Access Compliance Report

Public Rights-of-Way

Intersection ID: 21992	Main Street: WESTINGHOUSE_BV	Cross Street: S_TRYON_ST	Location: SW
ADA ID: 67089BA930E1	Ramp Type: PerpDiag	Initial Pass/Fail: Fail	Overall Compliance: No
		Severity Score: 12.5

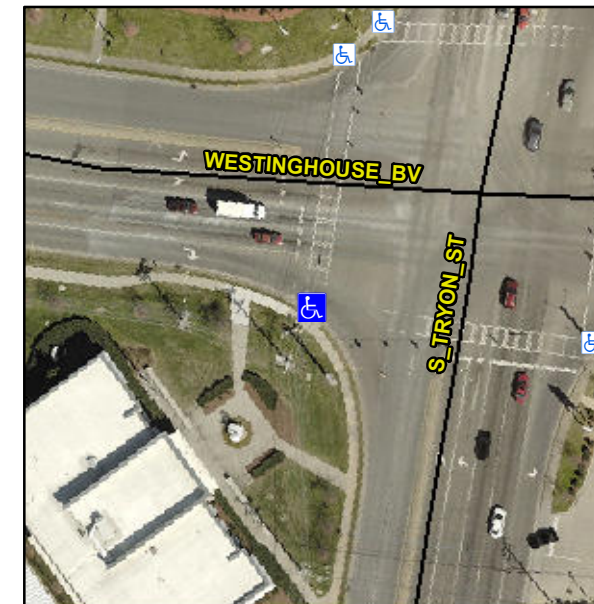
R304.2.2

Compliance	Description	Data	Compliance	Description	Data
N/A	Ramp Length (in)	91.0	No	Ramp Slope (%)	9.6
Yes	Ramp Width (in)	48.0	Yes	Ramp XSlope (%)	2.0
N/A	Flare Type LT	N/A	N/A	Flare Type RT	N/A
N/A	Flare Slope LT (%)	N/A	N/A	Flare Slope RT (%)	N/A
N/A	Flare Traversable LT?	N/A	N/A	Flare Traversable RT?	N/A
N/A	Landing Length (in)	N/A	N/A	DWS Provided?	N/A
N/A	Landing Width (in)	N/A	N/A	DWS Contrast?	N/A
N/A	Landing Slope (%)	N/A	N/A	DWS Length (in)	N/A
N/A	Landing X Slope (%)	N/A	N/A	DWS Full Width?	N/A
N/A	Landing Curb? (Y/N)	N/A	N/A	DWS Offset (in)	N/A
N/A	Shared Landing?	N/A			
N/A	Gutter Ponding?	N/A	N/A	Gutter Slope (%)	N/A
N/A	Gutter Lip Ht (in)	N/A	N/A	Gutter X Slope (%)	N/A
N/A	Painted X Walk1?	Yes	N/A	Painted X Walk2?	Yes
	X Walk 1 Direction	To E		X Walk 2 Direction	To N
N/A	X Walk 1 Width (in)	108.0	N/A	X Walk 2 Width (in)	111.0
	X Walk 1 Slope (%)	2.9		X Walk 2 Slope (%)	3.1
	X Walk 1 X Slope (%)	3.8		X Walk 2 X Slope (%)	2.3

Remove & Replace Curb Ramp With Two New Directional Ramps or Equivalent.
